**Historical Architectural Review Board  
COA Preliminary Review Sheet**

**HDC-2025-00102**

**Address: 521 N 6<sup>th</sup> Street**

**Proposal: Remove and install new decorative paneling around second floor bay window (Violation Correction)**

Wood Replacement/Current Condition (Applicant)

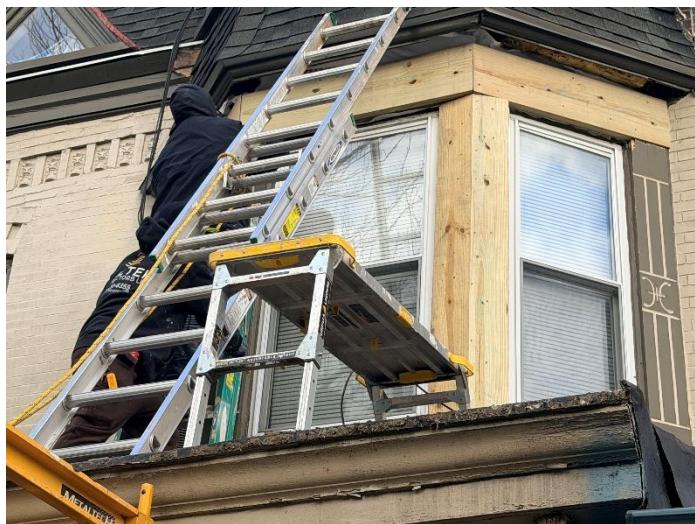
The proposed scope calls for adding new scribed trim onto replaced substrate. Based on the submitted photos, it appears that replacement wood is in plane with original scribed trim. More information would be helpful to understand how a consistent finished plane will be achieved; ensuring that edges align appropriately to adjacent elements, such as other trim and window sills.

**Staff Recommendation:** Staff request more information on the extent of the work area and the approach for achieving a consistent plane of the trim's surface. Generally, the proposed approach to replacing the wood trim is appropriate. All exposed wood surfaces should be painted.

The applicant noted that the new carved piece would be affixed to the new wood framing, and that it would be done in a way to maintain drip edges and continuity. He noted that the wood window sills are existing to remain, and confirmed that the work is only at the second floor bay window.
